This conceptual location analysis is for the siting of PV for power production.

This analysis is a **conceptual location study**. This study identifies proposed locations that have been selected based on long-range planning objectives, available land, and real property asset management requirements. Planning is at a conceptual level; the project has not been designed.

Proposed Sites (see maps)

Site 4 - Site 4 was eliminated because there is a 46kV overhead transmission line crosses the center of the site

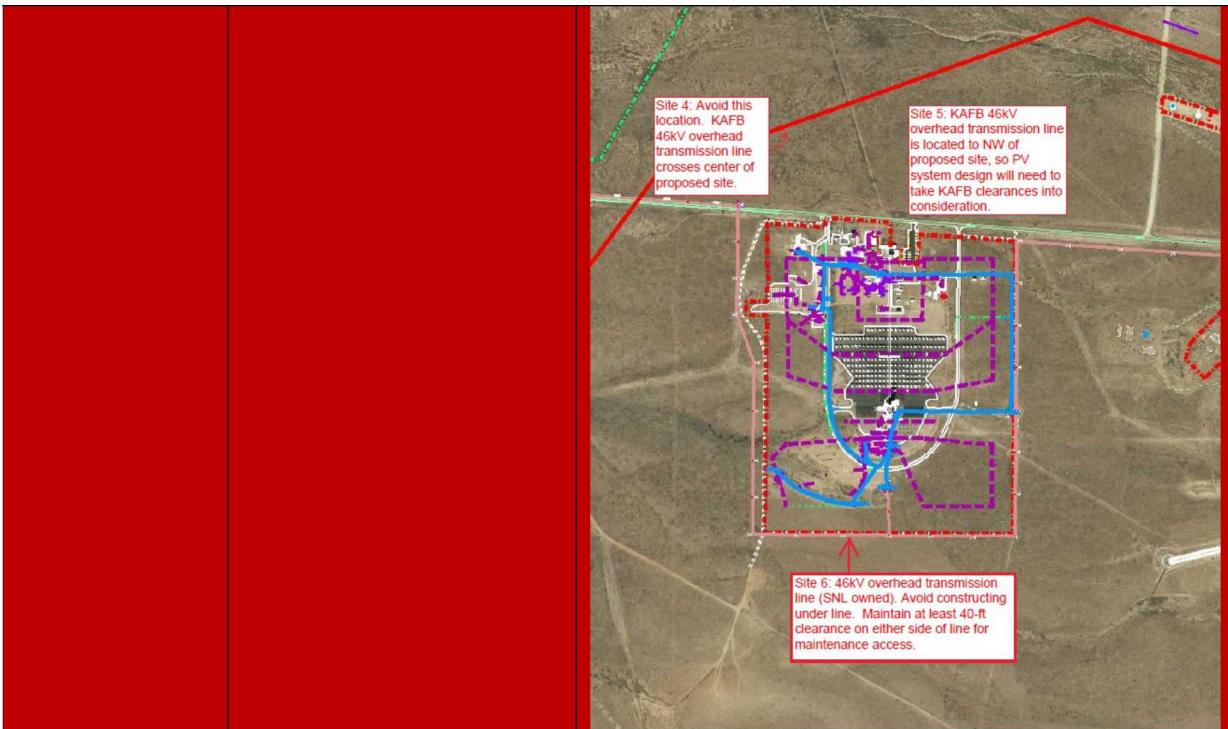
Proposed Site 4	SNL Department/Org	Comment
North of Solar Tower		
	<i>Environmental Permitting</i>	
	Stormwater	No issues
	Air Quality	No comments received
	Water Quality	No issues
	<i>NEPA & Ecology</i>	
	Ecology	No issues
	Historic	No comments received
	NEPA	<ul style="list-style-type: none"> Proposed locations are located on land permitted to DOE. AF approval would be required, including Siting, NEPA approval (AF813) and Real Estate interaction (332). Any work (i.e. buried transmission lines, utilities, etc.) that goes beyond the permit boundaries would require a new land use permit from the AF

<ul style="list-style-type: none"> • Could be a visual impact/cultural issue (Archaeology would address) • Recommend Planning NEPA • Construction NEPA required
	Archaeology	An archaeological survey will be required
	ER Sites	There are no LTS/ER issues. Any ER/LTS sites within the potential PV sites have completed remedial action with a determination of corrective action complete without controls
	Planning	
	Site Development	Recommend leaving utility corridors for access
	Landscape	No issues
	Real Estate	Site is located on a KAFB permit and will require coordination through Real Estate and NEPA
	Infrastructure (Civil & Electrical, Transportation)	
	Sanitary Sewer	No issues – there is a line to the south
	Natural Gas	No issues
	Storm Drainage (Civil)	<ul style="list-style-type: none"> • There are no storm drain lines in the area • There are some drainage paths through this area which would need to be considered during design. I do not see a major channel, but you will need to plan on corridors for water to pass through the site as part of the overall drainage plan • I fully expect that we would trigger EISA Section 438 requirements for retention

Communications (Civil)	No issues – there is a line to the east of the site
	Communications Service	The fiber connection point would be Building 9981. There is no underground infrastructure in place that could be utilized. Trenching would be required. There is limited space in the 1 equipment cabinet in Building 9981 for termination. Copper cabling is not available at this site
	Building & Fire Safety	No issues
	Traffic/ Transportation	No issues
	Electrical	Recommend avoiding this site. A KAFB owned 46kV overhead transmission line crosses the center of the proposed site

Existing Water Lines/ Underground Chilled Water	No issues
	Physical Security	No issues
	Conceptual ALARA Review	No ALARA review is required
	Development Cost & Project Schedule	Comments from electrical recommend not pursuing this site due to the KAFB owned 46kV overhead transmission line that crosses the site

Proposed Site 5	SNL Department/Org	Comment
North of Solar Tower		
	Environmental Permitting	
	Stormwater	No issues
	Air Quality	No comments received
	Water Quality	No issues
	NEPA & Ecology	
	Ecology	No issues
	Historic	No comments received
	NEPA	<ul style="list-style-type: none"> Proposed locations are located on land permitted to DOE. AF approval would be required, including Siting, NEPA approval

<p>(AF813) and Real Estate interaction (332). Any work (i.e. buried transmission lines, utilities, etc.) that goes beyond the permit boundaries would require a new land use permit from the AF</p> <ul style="list-style-type: none"> • Could be a visual impact/cultural issue (Archaeology would address) • Recommend Planning NEPA • Construction NEPA required
	Archaeology	An archaeological survey will be required
	ER Sites	There are no LTS/ER issues. Any ER/LTS sites within the potential PV sites have completed remedial action with a determination of corrective action complete without controls
	Planning	
	Site Development	Recommend leaving utility corridors for access
	Landscape	No issues
	Real Estate	Site is located on a KAFB permit and will require coordination through Real Estate and NEPA
	Infrastructure (Civil & Electrical, Transportation)	
	Sanitary Sewer	No issues – there is a line south of the site

Natural Gas	No issues
	Storm Drainage (Civil)	<ul style="list-style-type: none"> • There is no storm drain lines in the area • There are some drainage paths through this area which would need to be considered during design. I do not see a major channel, but you will need to plan on corridors for water to pass through the site as part of the overall drainage plan • I fully expect that we would trigger EISA Section 438 requirements for retention.
	Communications (Civil)	No issues – there is a line west of the site
	Communications Service	The fiber connection point would be Building 9981. There is no underground infrastructure in place that could be utilized. Trenching would be required. There is limited space in the 1 equipment cabinet in Building 9981 for termination. Copper cabling is not available at this site
	Building & Fire Safety	No issues
	Traffic/Transportation	No issues

Electrical	<p>This site is possible, but the KAFB transmission line mentioned in site 4 is located NW of the site</p>
	Existing Water Lines/ Underground Chilled Water	No issues
	Physical Security	No issues
	Conceptual ALARA Review	No ALARA review is required
	Development Cost & Project Schedule	There are some utility (electrical transmission line) avoidance issues that might reduce usable site size

Proposed Site 6	SNL Department/Org	Comment
South of Solar Tower		
	<i>Environmental Permitting</i>	
	Stormwater	No issues
	Air Quality	No comments received
	Water Quality	No issues
	<i>NEPA & Ecology</i>	
	Ecology	No issues
	Historic	No comments received

NEPA	<ul style="list-style-type: none"> Proposed locations are located on land permitted to DOE. AF approval would be required, including Siting, NEPA approval (AF813) and Real Estate interaction (332). Any work (i.e. buried transmission lines, utilities, etc.) that goes beyond the permit boundaries would require a new land use permit from the AF Could be a visual impact/cultural issue (Archaeology would address) Recommend Planning NEPA Construction NEPA required
	Archaeology	An archaeological survey will be required
	ER Sites	There are no LTS/ER issues. Any ER/LTS sites within the potential PV sites have completed remedial action with a determination of corrective action complete without controls
	Planning	
	Site Development	Recommend leaving utility corridors for access
	Landscape	No issues
	Real Estate	Site is located on a KAFB permit and will require coordination through Real Estate and NEPA

Infrastructure (Civil & Electrical, Transportation)	
	Sanitary Sewer	No issues
	Natural Gas	No issues
	Storm Drainage (Civil)	<ul style="list-style-type: none"> There are no storm drain lines in the area There are some drainage paths through this area which would need to be considered during design. There are some minor ones but there is one along the south edge that does appear to be major. You will need to design to protect the site from erosion from that major channel and you will need to plan on corridors for water to pass through the site as part of the overall drainage plan I fully expect that we would trigger EISA Section 438 requirements for retention
	Communications (Civil)	No issues
	Communications Service	The fiber connection point would be Building 9981. Trenching would be required from site to tunnel between Building 9980 & 9981. Fiber would need to be installed through ¼ mile tunnel to equipment

rack in 9981. There is limited space in the 1 equipment cabinet in Building 9981 for termination. Copper cabling is not available at this site
	Building & Fire Safety	No issues
	Traffic/ Transportation	No issues
	Electrical	<p>Site is acceptable but clearances from SNL owned 46kV transmission line must be maintained</p> 
	Existing Water Lines/ Underground Chilled Water	No issues
	Physical Security	No issues
	Conceptual ALARA Review	No ALARA review is required
	Development Cost & Project Schedule	Project schedule will be impacted by required KAFB coordination. There are potential historic and communication service issues

This analysis will inform a Request for Proposal. With the exception of Site 4, all sites are viable for the project and should be included as possible sites in the RFP. A Project NEPA checklist will be submitted for this project.

Site 1

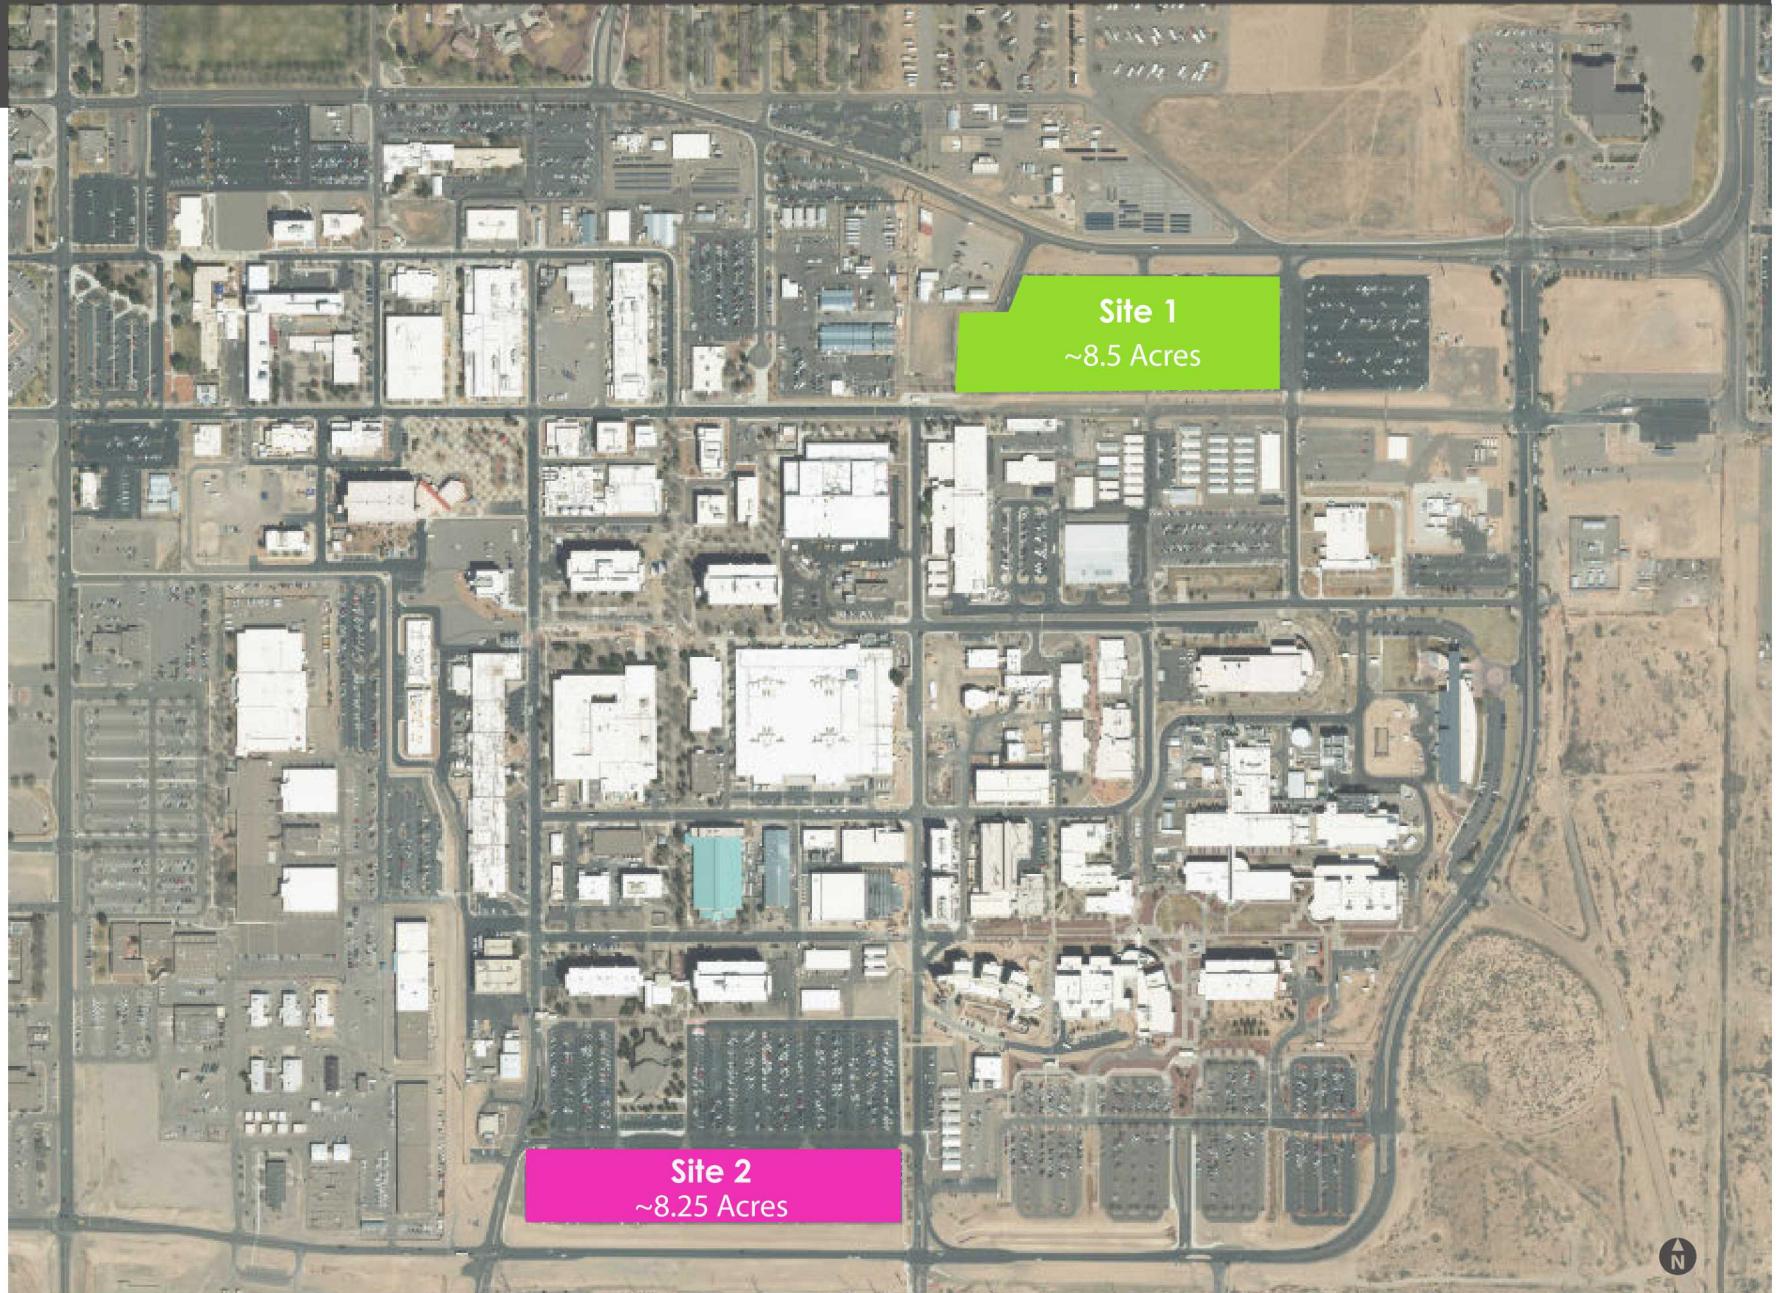
Proposed Site 1	SNL Department/Org	Comment
TA-I, Parking lot north of Building 887 (Water Tower)		
	<i>Environmental Permitting</i>	
	Stormwater	No issues
	Air Quality	No comments received

Water Quality	No issues
	NEPA & Ecology	
	Ecology	No issues
	Historic	No comments received
	NEPA	<ul style="list-style-type: none"> • A Planning NEPA is recommended • A construction NEPA is required • Site configuration may change due to 20th & G/Eubank Gate reconfiguration
	Archaeology	No issues
	ER Sites	No issues
	Planning	
	Site Development	<ul style="list-style-type: none"> • Include utility corridors for access • If there is a long-range intent to re-orient the parking lot 90 degrees, it should be done with this project • Design should include consideration of snow removal
	Landscape	No issues
	Real Estate	No issues
	Infrastructure (Civil & Electrical, Transportation)	
	Sanitary Sewer	No issues
	Natural Gas	No issues
	Storm Drainage (Civil)	<ul style="list-style-type: none"> • Currently, there are no storm drain lines in the area. However, with the 20th and G Project, there might be some storm drain lines at the northeast corner and perhaps along the north. Additionally, there might be some storm drain lines put in at the northwest over to the detention basin after the project, to help reduce the size of the detention basins next to 18th Street. Please keep this in mind during siting at those corners • Many years ago, a project was developed to install underground drainage piping in the parking area to reduce the depth of flow in the parking lot. I will have to look it up to see if that is still in the system waiting for funding; it was submitted two tracking systems ago and some things disappeared in the translation. There are no inlets in that large parking lot and the flows can get quite

<p>deep by the west end, sometimes creating hazards for those venturing out in a large rainfall event. It would be a good idea to look at those proposals, to provide corridors for the drainage piping and inlets so that this could still be done in the future</p> <ul style="list-style-type: none"> • If we are just putting in covered parking with solar panels on top, I don't think we would trigger EISA Section 438 requirements because we are not actively regrading the parking lot. However, if the parking lot gets regraded at the same time, then Section 438 would apply • Recommend repaving the parking lot with this project, or at least providing a design sufficient to allow for safe repaving in the future • The panels would not increase the amount of runoff or its speed. However, it would concentrate it in ways it had not before as now the water would run directly to the aisles. This would need to be considered during the design and might actually be a good reason for some of the storm drainage improvements mentioned in item 2 above

Communications (Civil)	<p>There are no communication lines in the site, but there are lines at the perimeter that should be considered during design</p>
	Communications Service	<ul style="list-style-type: none"> • Comments assume that a network connection for metering/monitoring is required • There are 4 telecom maintenance holes location on H Avenue that could be accessed. Fiber connection point would be in Building 880. If copper is required, the nearest copper splice case would be accessed
	Building & Fire Safety	No issues
	Traffic/ Transportation	If this site is selected, it should be designed so that there is no loss of parking spaces
	Electrical	Site is acceptable but existing parking lot lighting should be taken into consideration

<p>Site 1 (North Parking Lot)</p> <p>Be aware of parking lot lighting (underground lighting and surface line) during PV system design and construction</p> <p>MONITORED WATER MONITOR MONITOR</p>
	Existing Water Lines/ Underground Chilled Water	No issues
	Physical Security	No issues
	Conceptual ALARA Review	No ALARA review is required
	Development Cost & Project Schedule	Covered parking will increase cost

Proposed Site 2	SNL Department/Org	Comment
TA-I, Parking lot south of Steve Schiff		
	<i>Environmental Permitting</i>	
	Stormwater	No issues
	Air Quality	No comments received
	Water Quality	No issues
	<i>NEPA & Ecology</i>	
	Ecology	No issues
	Historic	No comments received
	NEPA	<ul style="list-style-type: none"> • A Planning NEPA is recommended • Construction NEPA is required • Area is scheduled for an increase in available parking to the south (north side of Hardin Blvd)—probably not a conflict but could add additional parking area available for PV
	Archaeology	No issues
	ER Sites	This site has two groundwater monitoring wells located within the proposed PV production site boundaries (see attached map). These monitoring wells must not be disturbed during PV construction activities. Groundwater samples are collected from

<p>these wells twice a year and our groundwater sample team will require unimpeded access to the monitoring well locations. The wells are constructed flush to the ground surface and may be difficult to notice</p> 
	Planning	
	Site Development	<ul style="list-style-type: none"> Include utility corridors for access Design should include consideration of snow removal If there is a long-range intent to re-orient the parking 90 degrees, do it with this project There is a planned project to add additional parking south of this lot with Section 438 retention at the southwest corner – consider this in design
	Landscape	No issues
	Real Estate	N/A (site is on DOE property)
	Infrastructure (Civil & Electrical, Transportation)	
	Sanitary Sewer	There is a major sewer line along the east end of this parking area. The east end parking spaces would most likely not be able to be covered
	Natural Gas	There are major feeds to the south on the west and east side of Site 2. No construction should be done over these lines

Storm Drainage (Civil)	<ul style="list-style-type: none"> Currently, there is a storm drain on a diagonal at the northwest corner. Space would have to be provided so that the pipe could be removed without removing the panels

<ul style="list-style-type: none"> • Many years ago, a project was developed to install underground drainage piping in the parking area to reduce the depth of flow in the parking lot. I will have to look it up to see if that is still in the system waiting for funding; it was submitted two tracking systems ago and some things disappeared in the translation. There are no inlets in that large parking lot and the flows can get quite deep by the west end, sometimes creating hazards for those venturing out in a large rainfall event. It would be a good idea to look at those proposals, to provide corridors for the drainage piping and inlets so that this could still be done in the future • If we are just putting in covered parking with solar panels on top, I don't think we would trigger EISA Section 438 requirements because we are not actively regrading the parking lot. However, if the parking lot gets regraded at the same time, then Section 438 would apply • Recommend repaving the parking lot with this project, or at least providing a design sufficient to allow for safe repaving in the future • The panels would not increase the amount of runoff or its speed. However, it would concentrate it in ways it had not before as now the water would run directly to the aisles. This would need to be considered during the design and might actually be a good reason for some of the storm drainage improvements mentioned in item above

Communications (Civil)	No issues
	Communications Service	<ul style="list-style-type: none"> • Comments assume that a network connection for metering/monitoring would be required • There are 3 telecom maintenance holes located on the south side of Hardin Blvd. or 1 maintenance hole located to the west of the site on 9th St. that could be accessed. Fiber connection point would Building 821.

If copper is required the nearest copper splice would be accessed
	Building & Fire Safety	No issues
	Traffic/ Transportation	If this site is selected, it should be designed so that there is no loss of parking spaces
	Electrical	Site is acceptable but existing parking lot lighting should be taken into consideration. Also, there is an electrical ductbank at the far west end of the proposed site, but it shouldn't be an issue  Site 2 (South Parking Lot) Avoid construction over 12.47kV electrical ductbank Be aware of parking lot lighting underground circuit (green lines) during PV system design and construction
	Existing Water Lines/ Underground Chilled Water	No issues
	Physical Security	No issues
	Conceptual ALARA Review	No ALARA review is required
	Development Cost & Project Schedule	Covered parking will add cost, there are some utility and water monitoring well avoidance issues that might reduce usable site size

Site 3

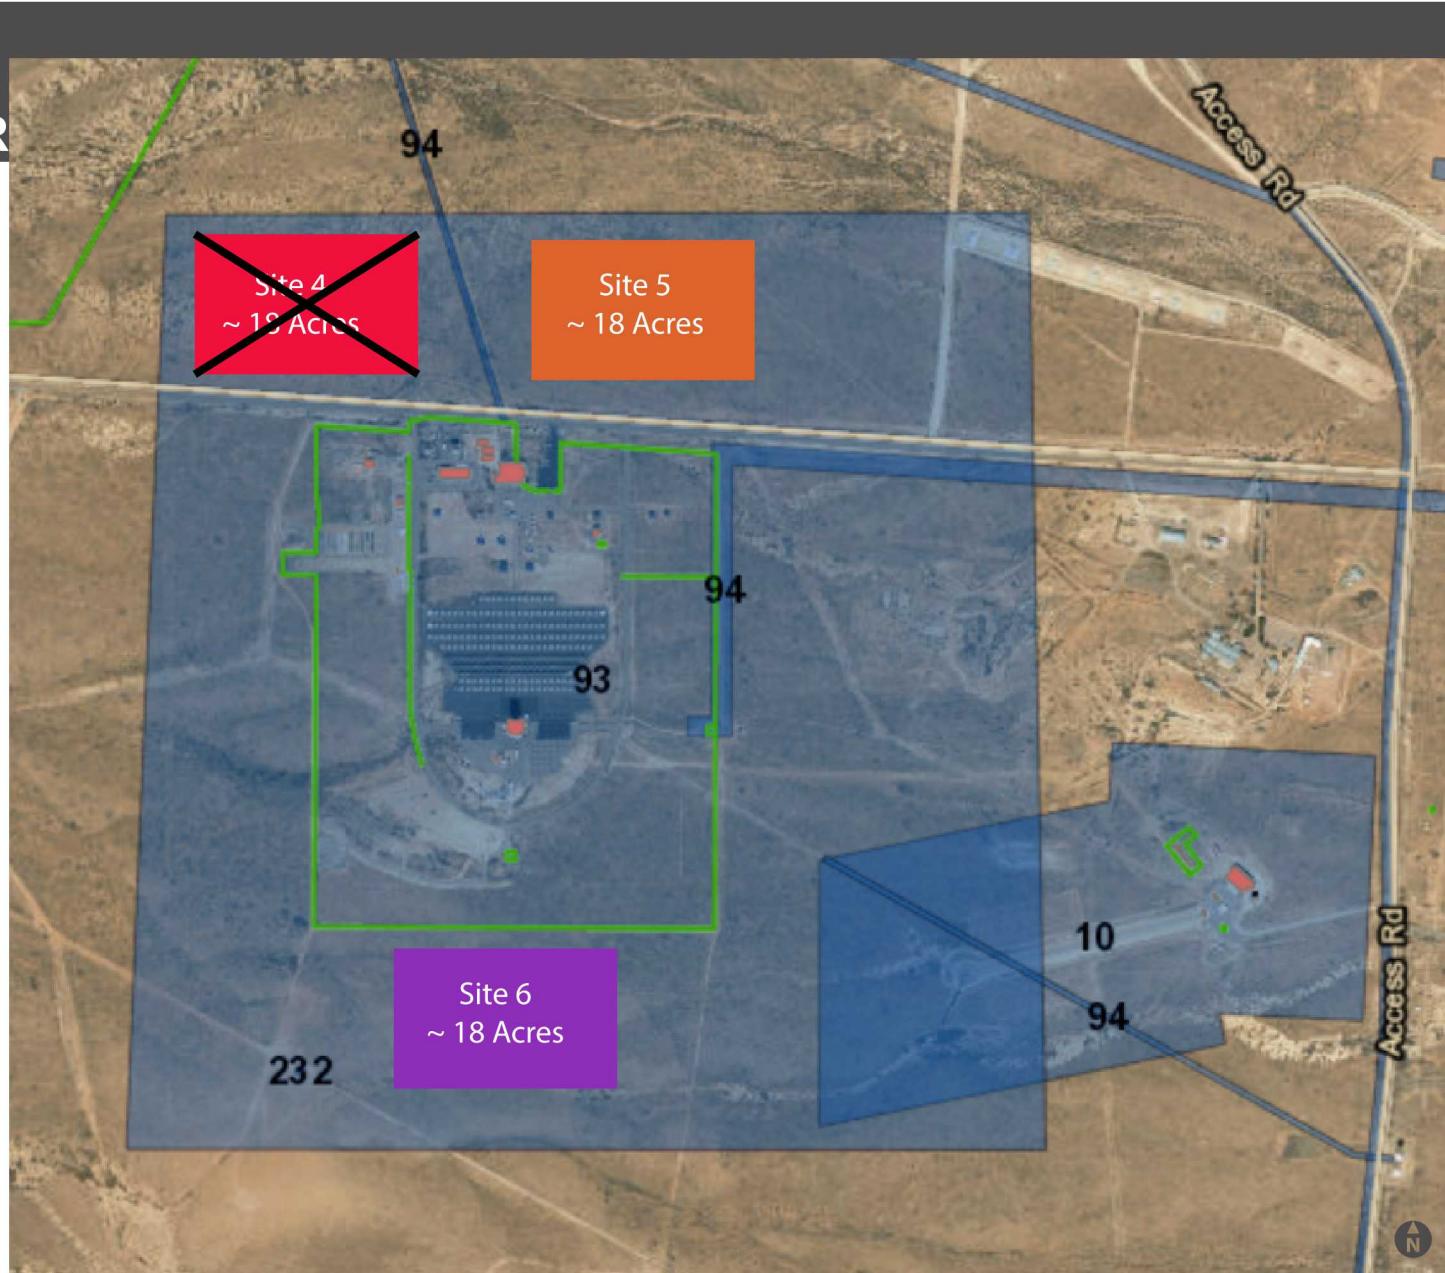
Proposed Site 3	SNL Department/Org	Comment
TA-IV, Parking Lot west of Building 960		
	<i>Environmental Permitting</i>	
	Stormwater	No issues
	Air Quality	No comments received
	Water Quality	No issues
	<i>NEPA & Ecology</i>	
	Ecology	No issues
	Historic	No comments received
	ER Sites	The Tech Area IV PV Production Site 3 has one former ER drain line (ER Site 226) that runs north to south through PV Site 3. ER Site 226 has completed the regulatory process with a determination of Corrective Action Complete with Controls. However, as long as you don't anticipate

<p>excavating deeper than 4 to 8 feet below grade I don't believe this would restrict the use of this site for your project</p> 
	NEPA	<ul style="list-style-type: none"> Western half of this area currently contains the 600 MVA Transformer and is slated for a temporary tent structure adjacent to the transformer. Eventual transformer removal could be problematic if PV mounted on overhead structures No issues with covered parking PV on eastern side of the area. Recommend planning NEPA Construction NEPA required
	Archaeology	No issues
	Planning	
	Site Development	<ul style="list-style-type: none"> Recommend providing utility corridors for access Design should include consideration of snow removal
	Landscape	No issues
	Real Estate	N/A (site is on DOE property)
	Infrastructure (Civil & Electrical, Transportation)	
	Sanitary Sewer	<ul style="list-style-type: none"> There is a major sewer line along the west end of this parking area. The west end parking spaces would not be able to have the covered parking There is an abandoned sewer line in this area at the west. It can be removed and

built over but might have some ER site complications
	Natural Gas	There is a major feed to TA-IV that runs along the north side of Site 4. No construction should be done over this line
	Storm Drainage (Civil)	<ul style="list-style-type: none"> Currently, there is some storm drain along the edges of the parking areas. Don't build over them, and space would have to be provided so that the pipe could be removed without removing the panels If we are just putting in covered parking with solar panels on top, I don't think we would trigger EISA Section 438 requirements because we are not actively regrading the parking lot. However, if the parking lot gets regraded at the same time, then Section 438 would apply. Recommend repaving the parking lot with this project, or at least providing a design sufficient to allow for safe repaving in the future The panels would not increase the amount of runoff or its speed. However, it would concentrate it in ways it had not before as now the water would run directly to the aisles. This would need to be considered during the design

Communications (Civil)	No issues
	Communications Service	There is very limited access to telecom maintenance holes on the west side of Building 960. The duct bank infrastructure requires abandon cabling to be removed and there is limited access into Building 960. Fiber connection point would be Building 960. If copper is required the nearest copper slice case would be accessed
	Building & Fire Safety	No issues
	Traffic/ Transportation	If this site is selected, it should be designed so that there is no loss of parking spaces
	Electrical	There is a 115kV transmission line and an electrical ductbank at the west end of the site that would reduce usable site size

Existing Water Lines/ Underground Chilled Water	No issues
	Physical Security	No issues
	Conceptual ALARA Review	No ALARA review is required
	Development Cost & Project Schedule	Covered parking will add cost and there are some utility avoidance issues that might reduce usable site size
